# Proposed 11 Unit Townhouses

**1603 & 1605 86th St E, and 1604 87th St E.**
**Bloomington, MN**

SHEET TITLE
PROPOSED SITE PLAN

SHEET NO.
A3

1 PROPOSED SITE PLAN
SCALE: 1" = 20'-0"

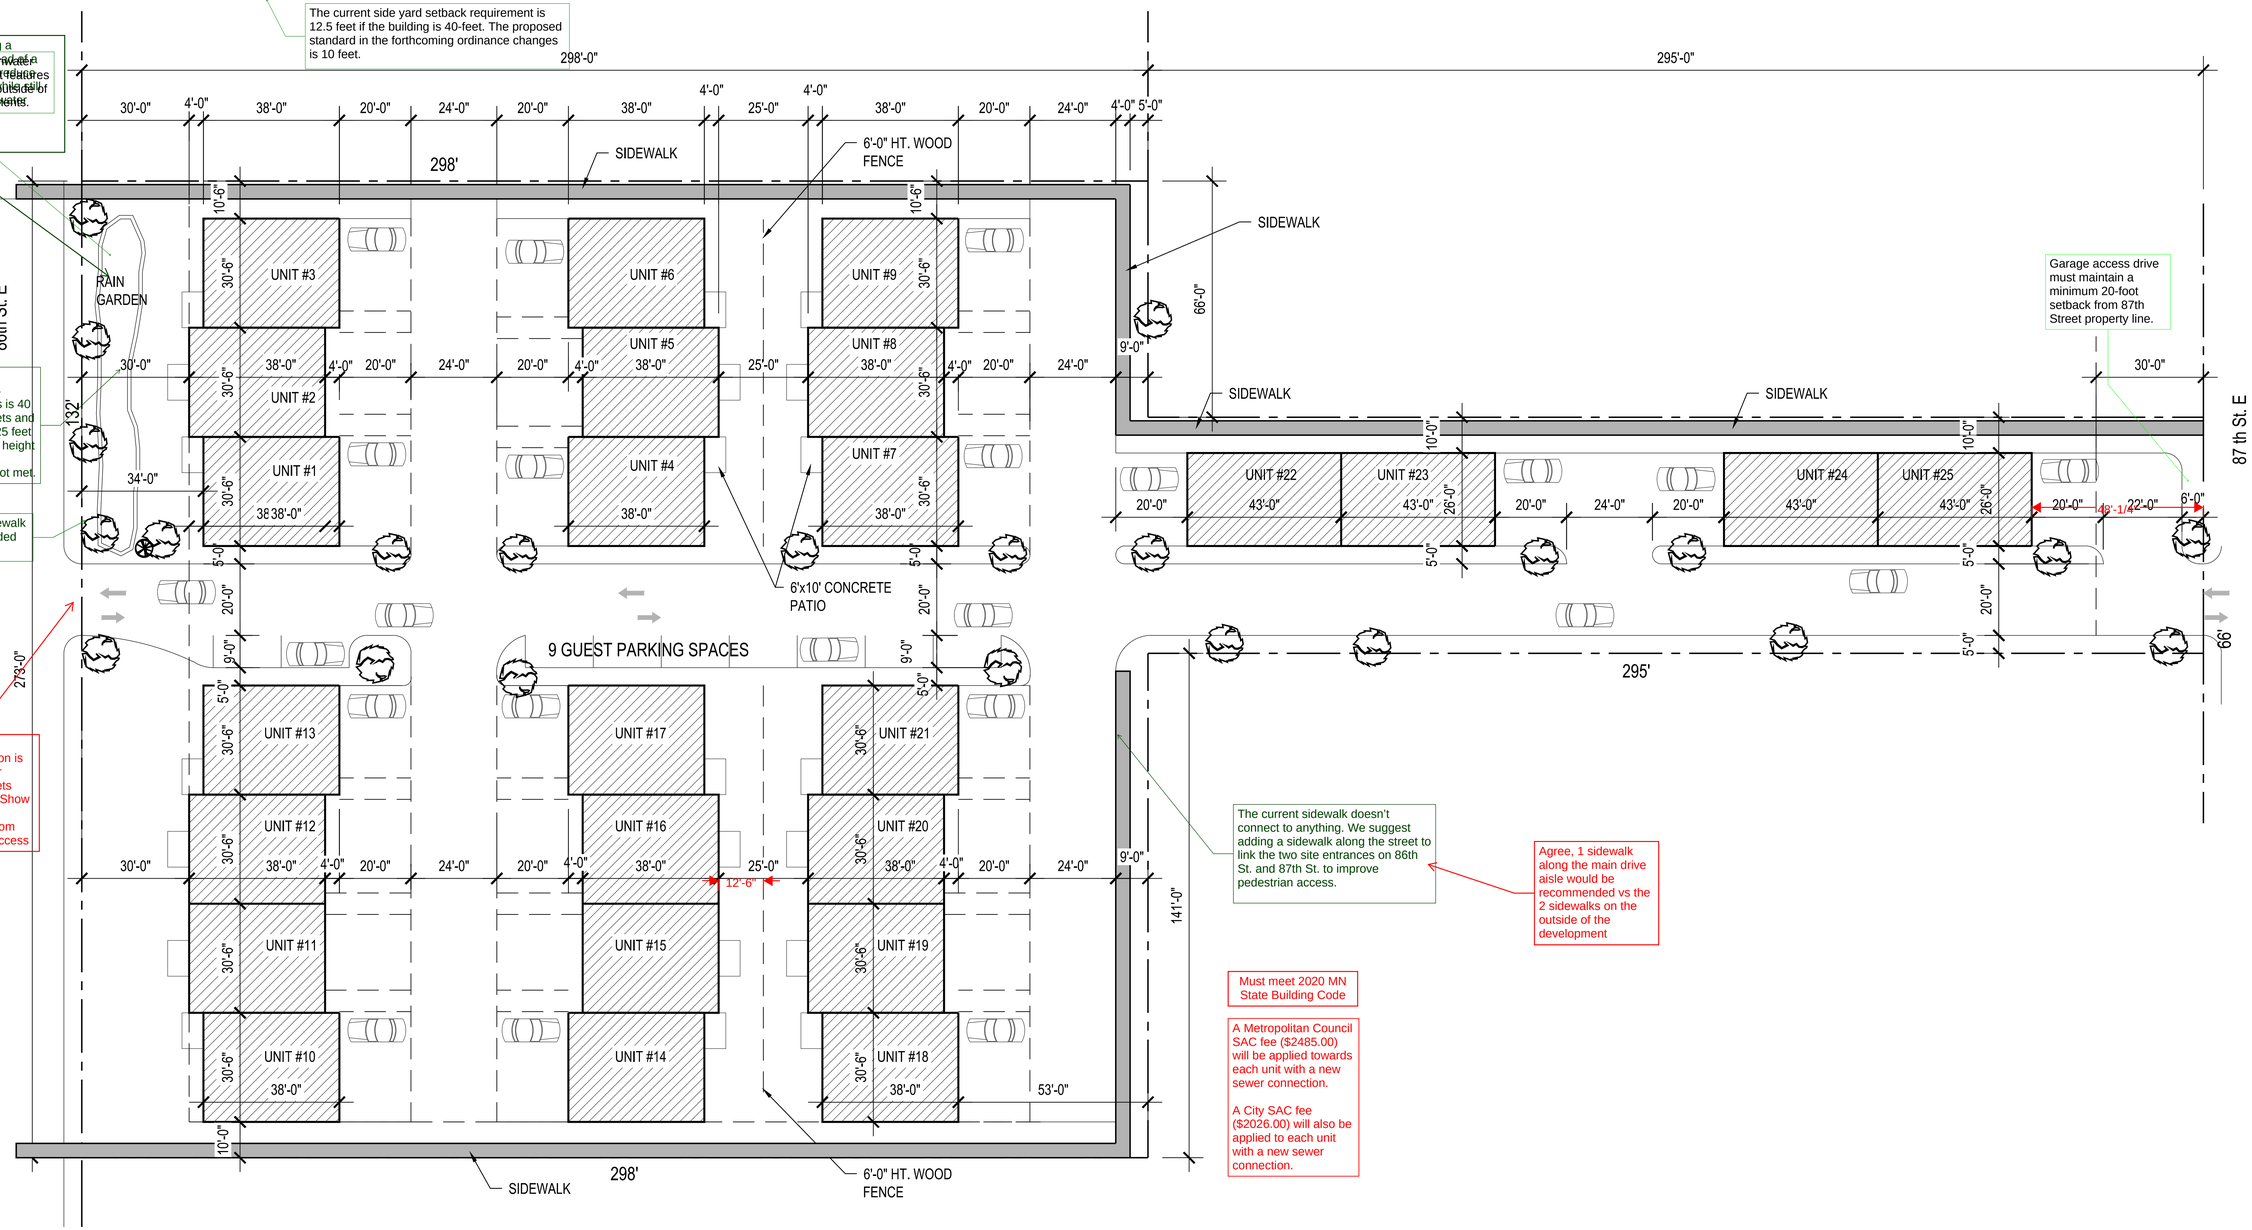
Update the site data to reflect accurate information/proposal

Sprinkler protection (13D system) will be required for buildings with more than 2 units.

Show locations of neighboring houses - will want to identify vegetation/screening that will be provided on your site to screen headlights from the internal driveways on this site.

The current side yard setback requirement is 12.5 feet if the building is 40-feet. The proposed standard in the forthcoming ordinance changes is 10 feet.

Consider using a bioretention feature as a rainwater management feature. Ensure stormwater management features are located outside of public easements.

The minimum setback for R-4 Zoning Districts is 40 feet along streets and 10 feet plus 0.25 feet for each foot in height over 30 feet. Setbacks are not met.

An 8-foot sidewalk must be provided along 86th St.

Show where driveway location is relative to other driveways/streets along 86th St. Show house location across street from this driveway access

Garage access drive must maintain a minimum 20-foot setback from 87th Street property line.

The current sidewalk doesn't connect to anything. We suggest adding a sidewalk along the street to link the two site entrances on 86th St. and 87th St. to improve pedestrian access.

Agree, 1 sidewalk along the main drive aisle would be recommended vs the 2 sidewalks on the outside of the development

Must meet 2020 MN State Building Code

A Metropolitan Council SAC fee ($2485.00) will be applied towards each unit with a new sewer connection.

A City SAC fee ($2026.00) will also be applied to each unit with a new sewer connection.
